ADDENDUM NO. 1

Project Designation: 16070 - JJSD #251 Harwood Elementary Addition and Remodel

For: Jefferson Joint School District No. 251

Date: April 29, 2019

PROJECT:
 REVISIONS
 1 ADDENDUM #1 2019-05-02

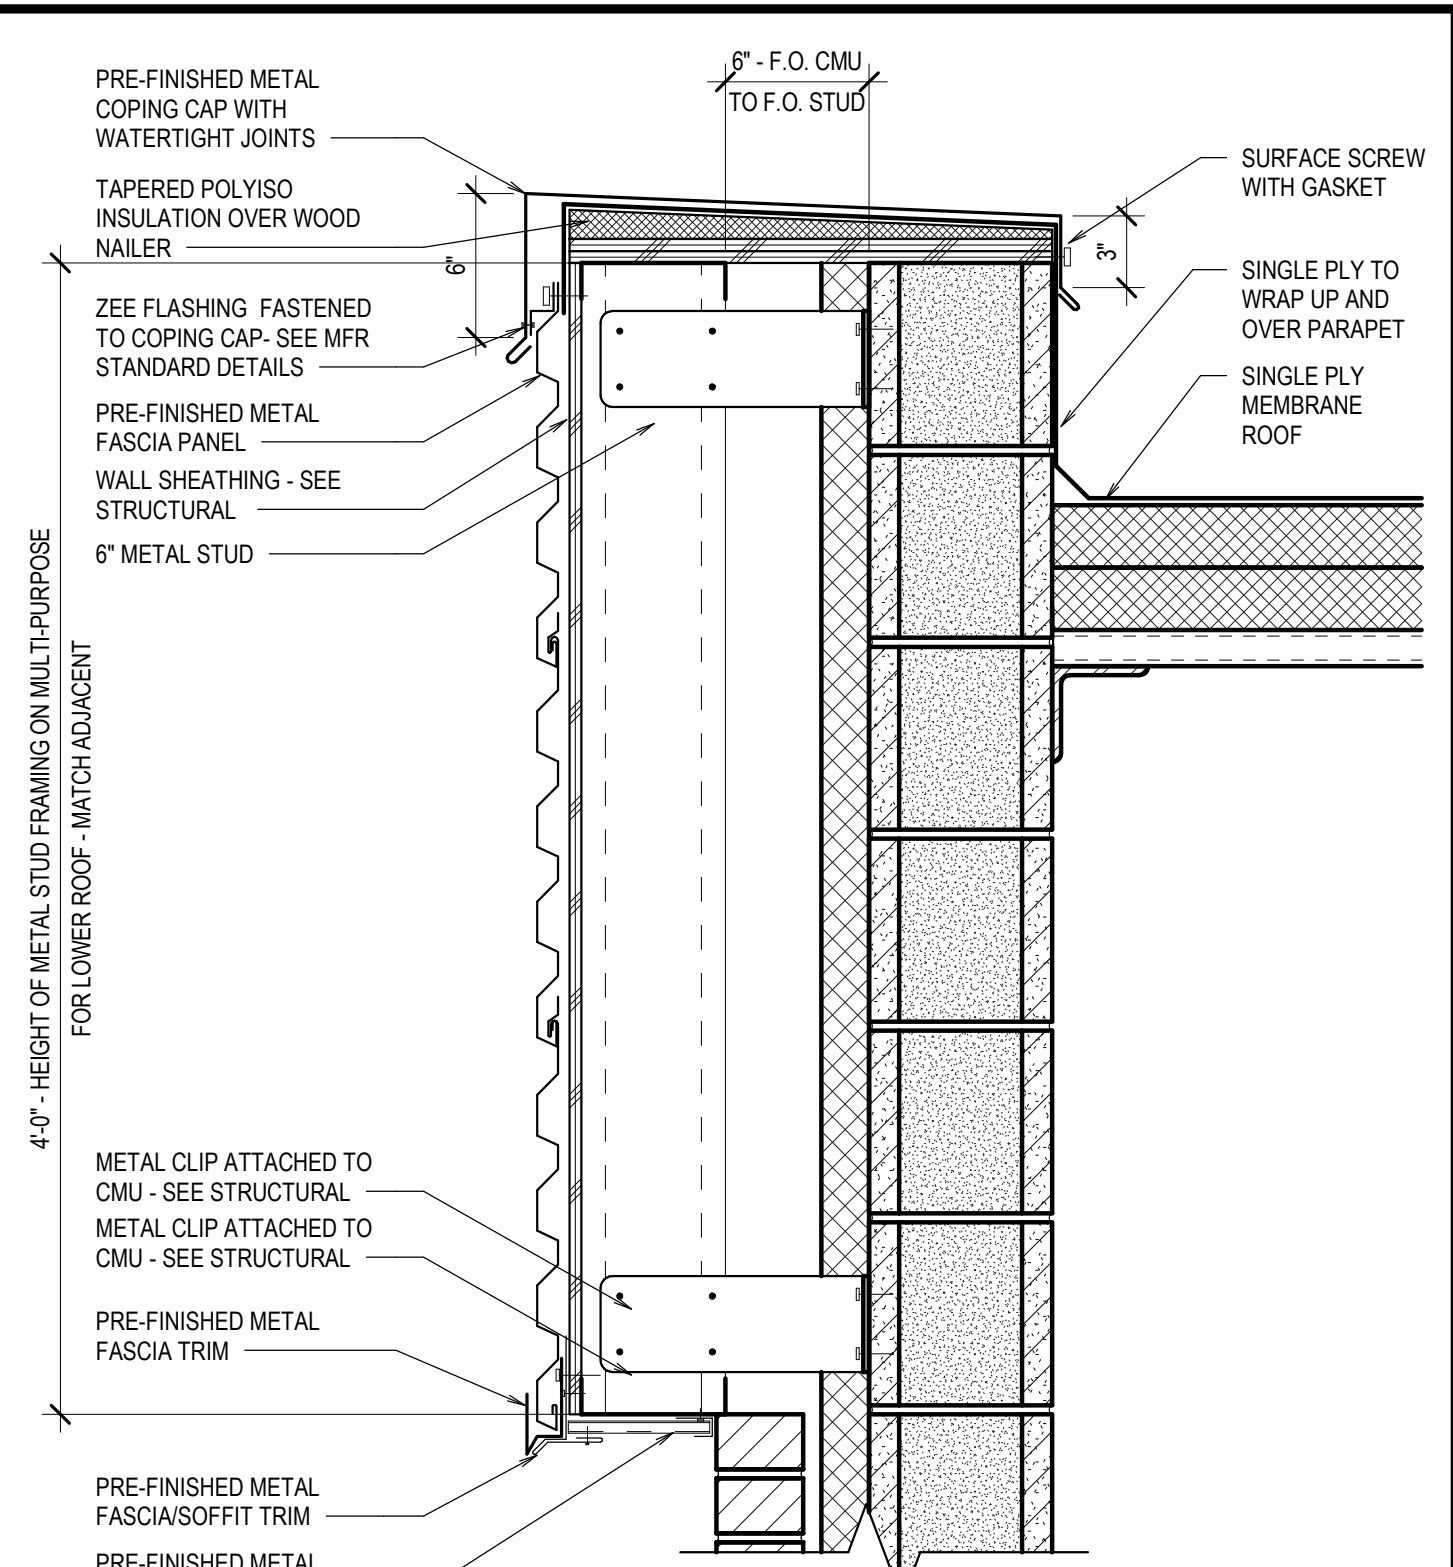
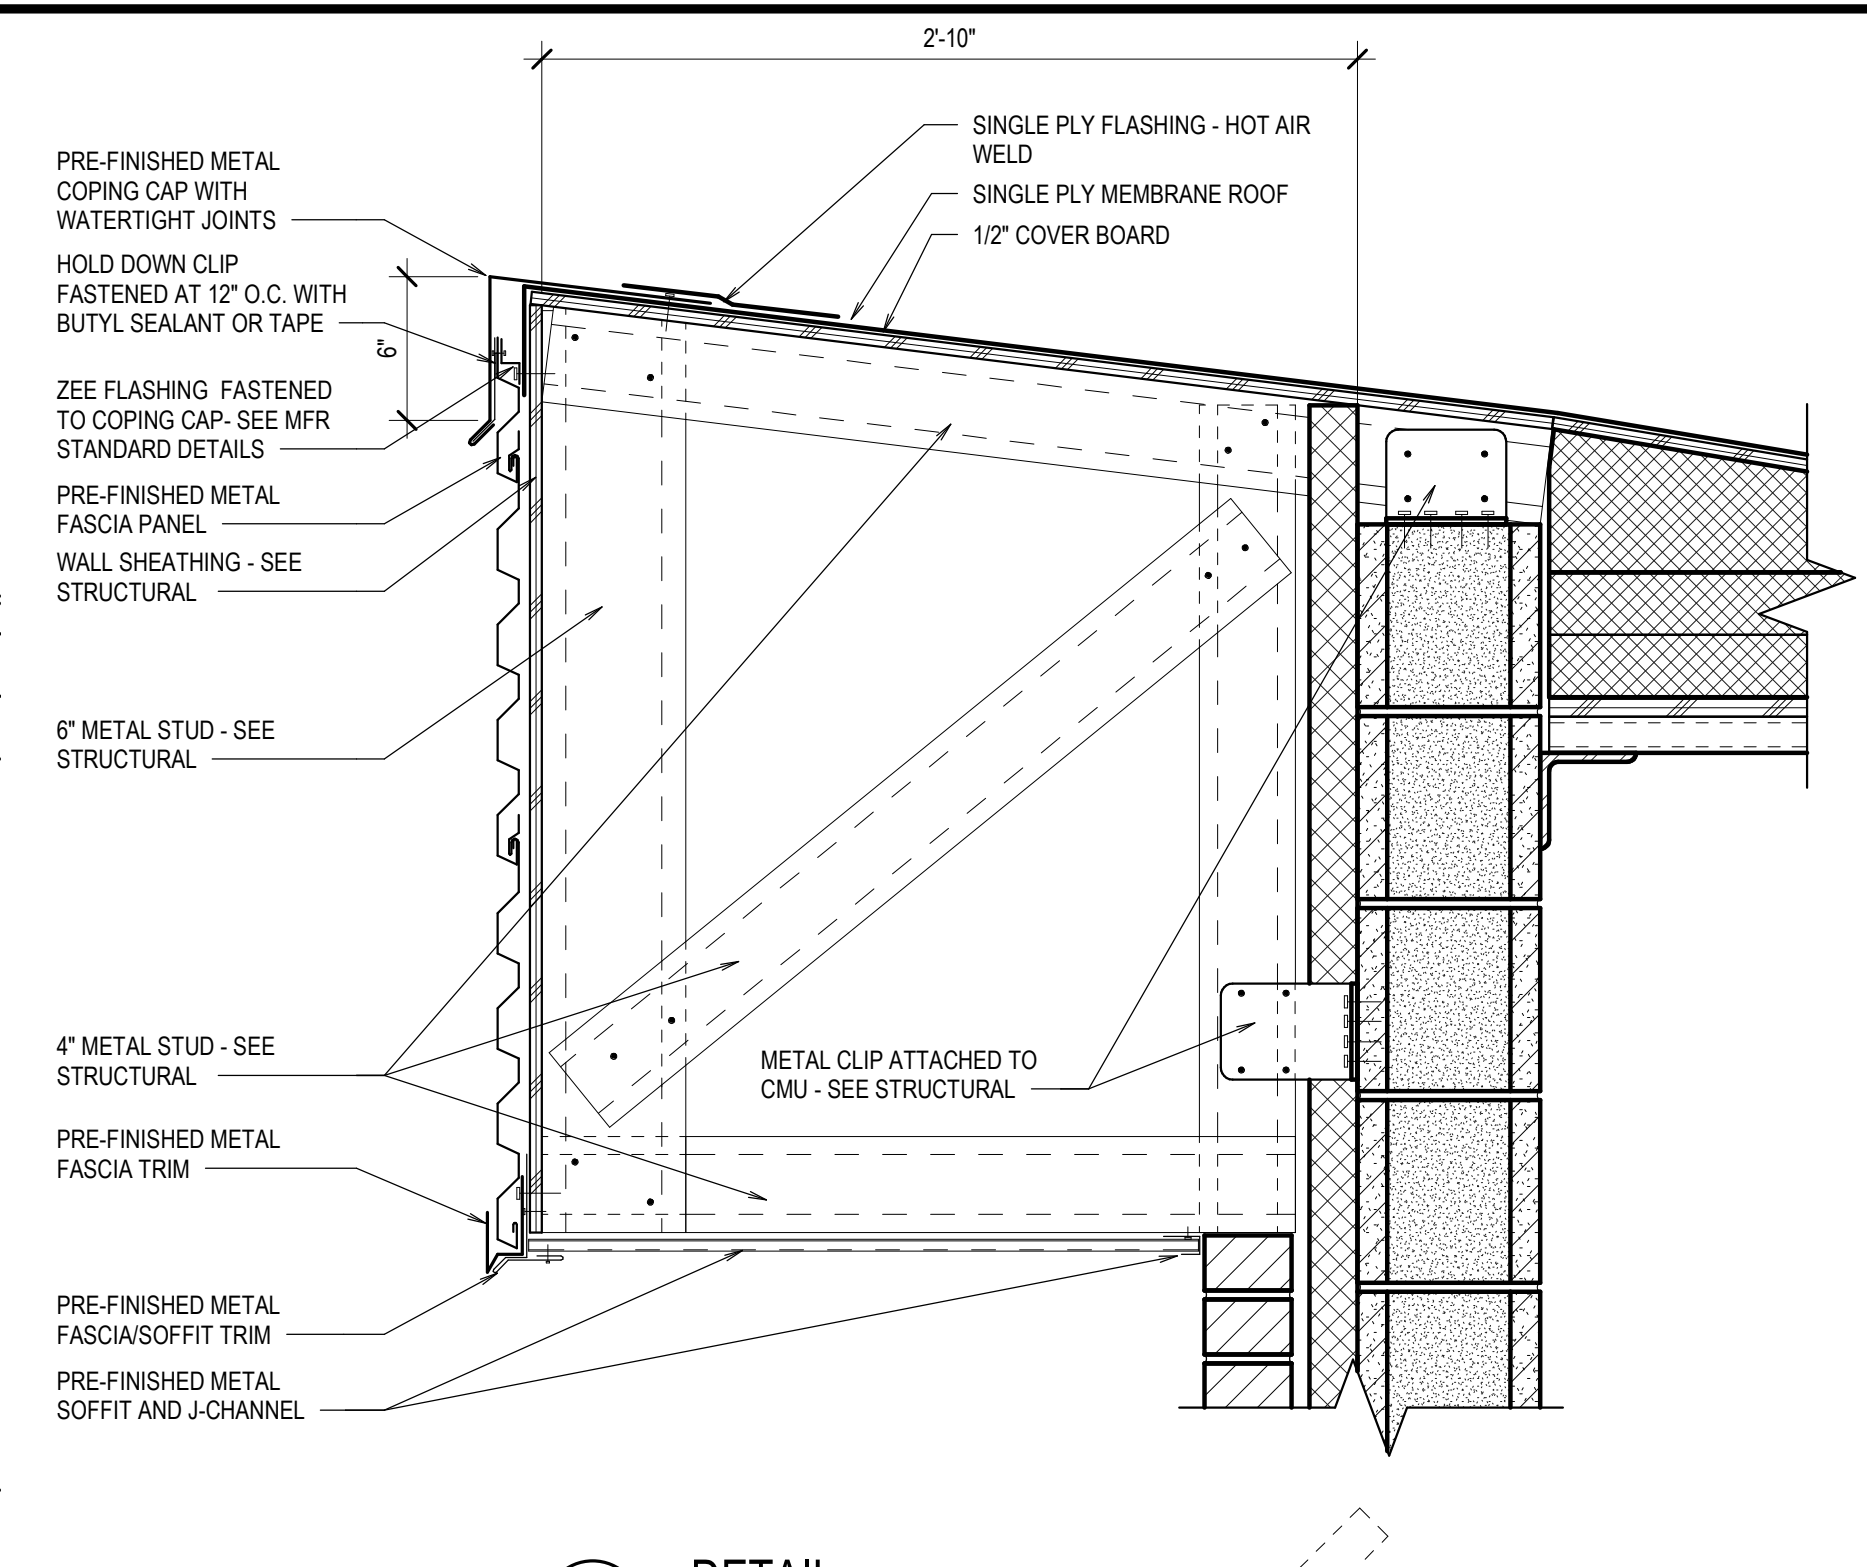
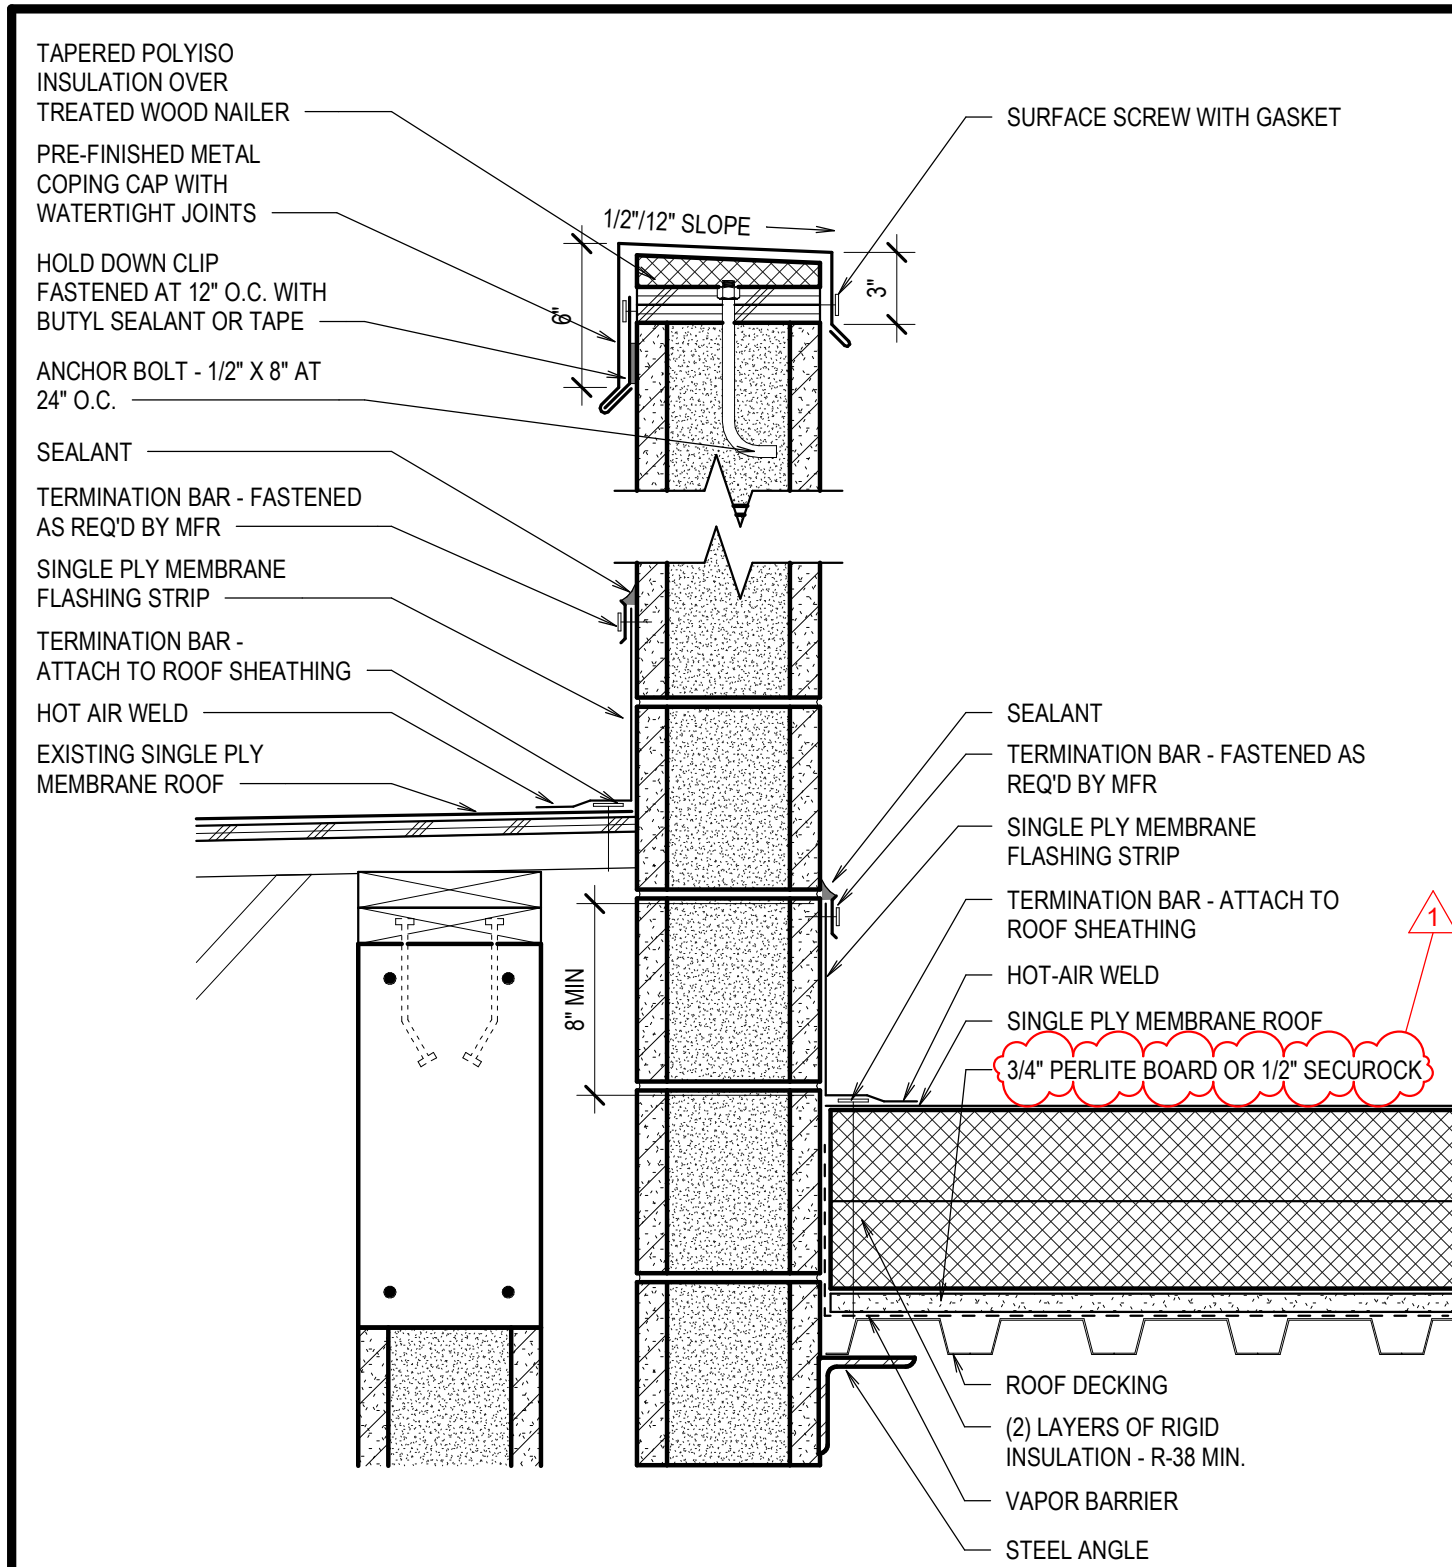
11. See revised sheet **A7.2 – 7.3**
 - a. Added 1/2" Securock as an option instead of Perlite Board to all roof details.

DRAWING NO.:
SD1.2

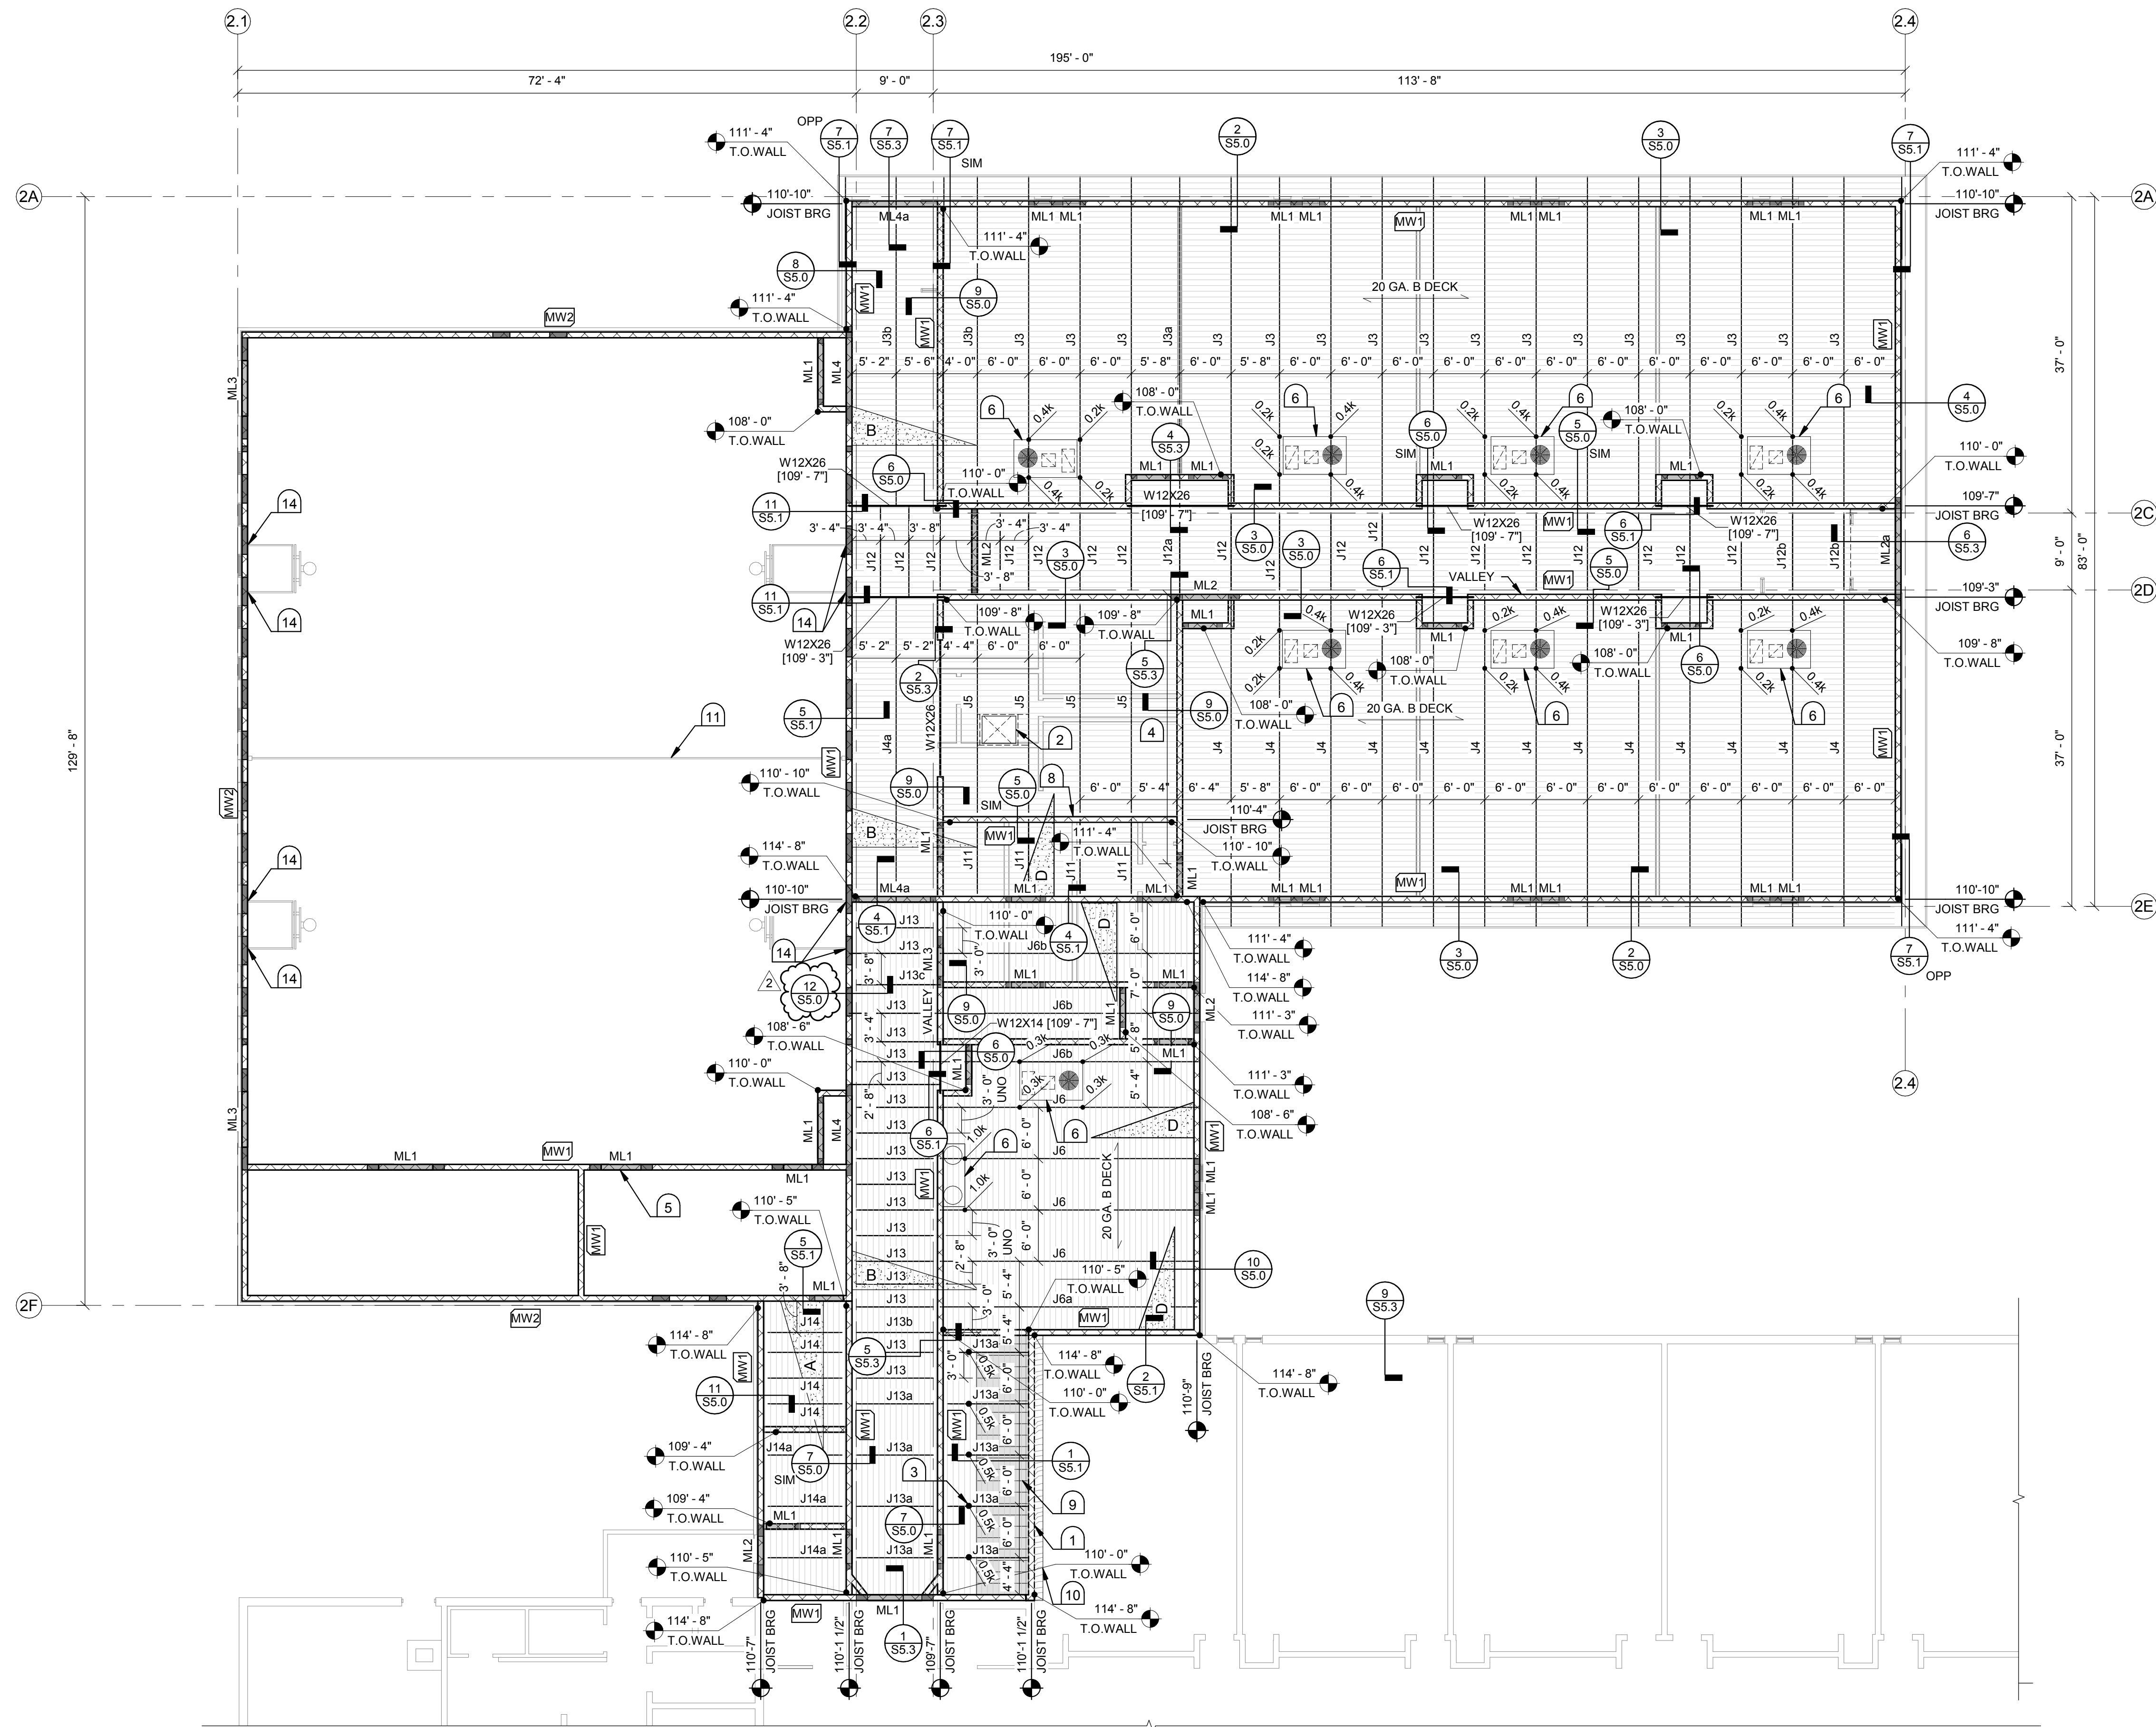
- c. Basketball Hoops added and adjusted.
2. See revised sheet **SD1.2**
 - a. Details updated and added.
3. See revised sheet **A0.1**
 - a. Demolition Note #10 was changed. Callouts for removing the fence.
